1988 - 1990 Corvette: Service Bulletin: Power Steering Shudder / Groan

Subject: POWER STEERING SHUDDER/GROAN INSTALL P/S COOLER & HOSE

Model and Year: 1988-90 CORVETTE WITH 5.7L ENGINE

Bulletin Number: 90-376-3B - (10/25/1990)

Step B Illustration

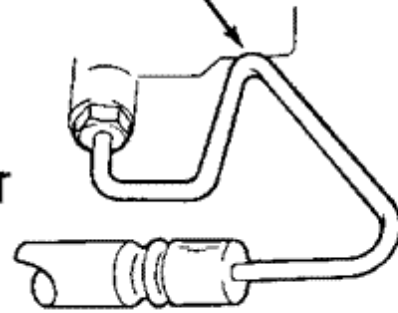
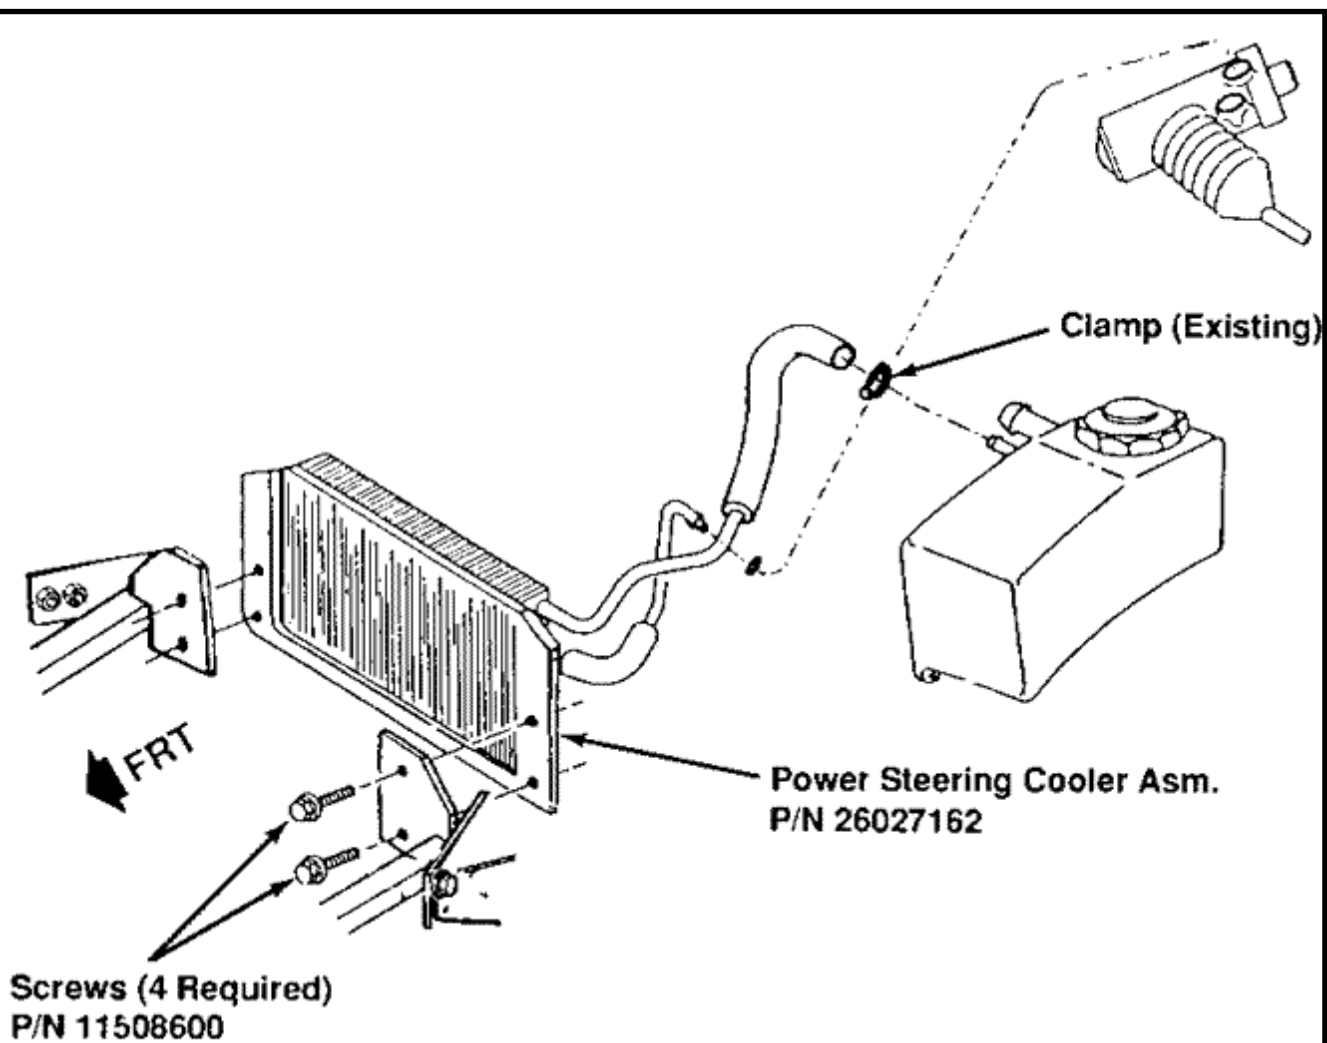
Replace existing pressure/inlet hose (pump to steering gear) with new assembly with internal tuner cable.

Power Steering
Pressure/Inlet Hose Asm.
P/N 262027177

Pipe at Pump End of
Hose Asm. is to be
Against Lower Corner
of Pump

Torque Specifications
Fittings (Pressure/Inlet Hose) – 28 N·m (21 lbs. ft.)

Step C Illustration (1990 Vehicles)

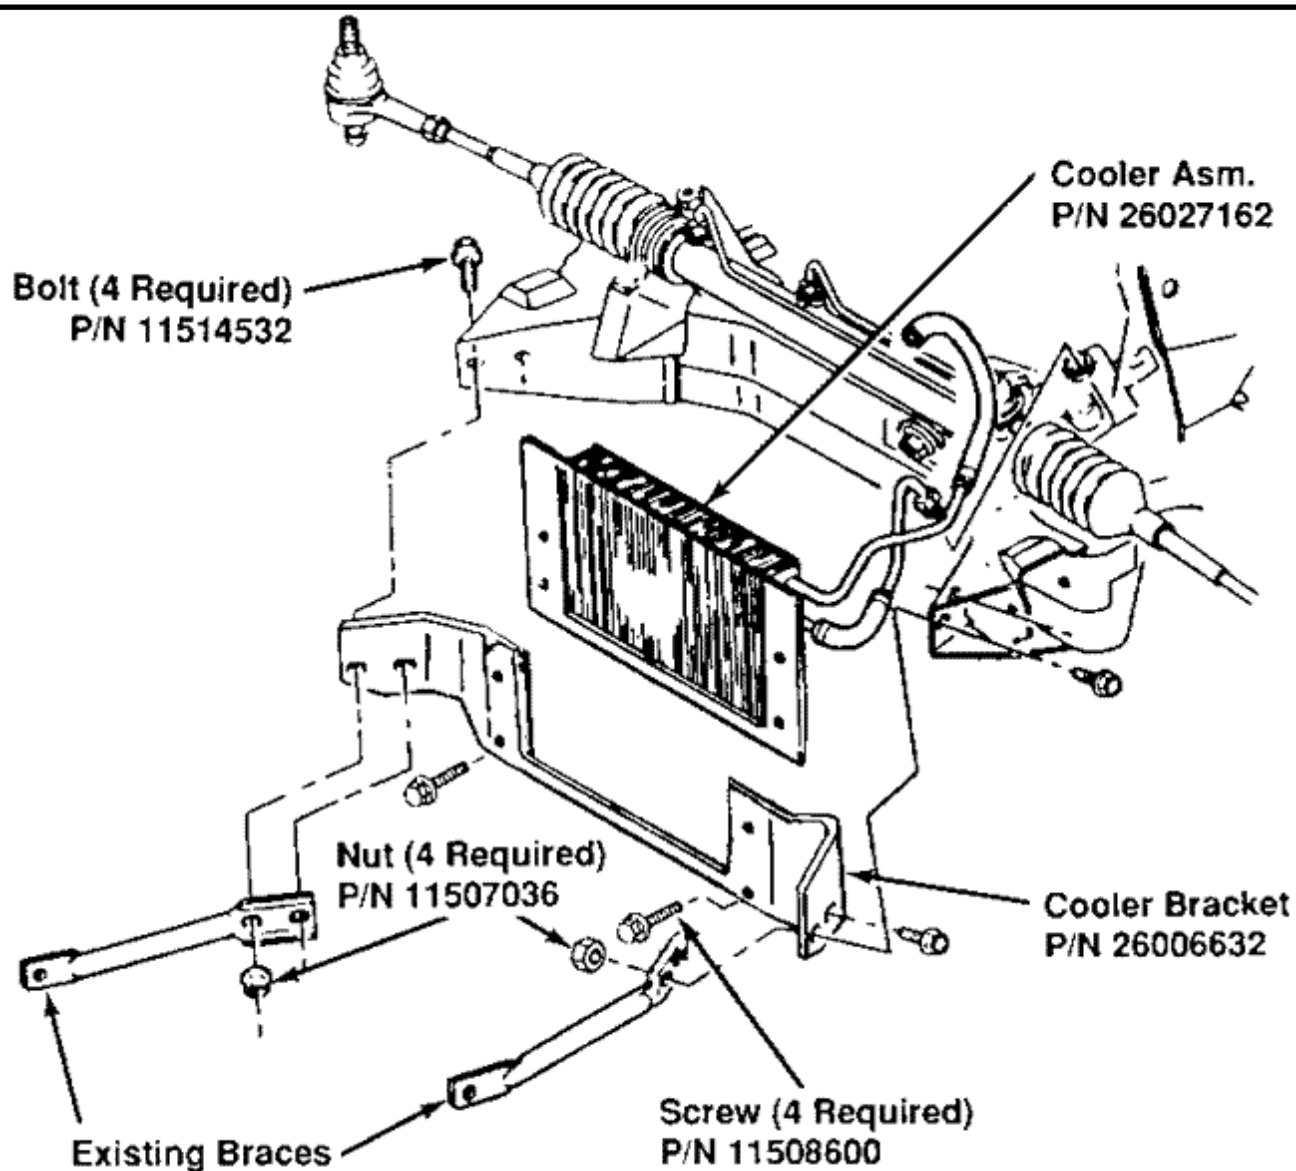
Replace existing power steering loop/pipe cooler with finned cooler that includes return hose with tuner cable.

Torque Specifications

Fitting (Return/Outlet Hose) – 28 N•m (21 lbs. ft.)

Clamp (Reservoir Hose) – 2.5 N•m (22 lbs. in.)

Screws (Cooler/Bracket) – 10 N•m (89 lbs. in.)
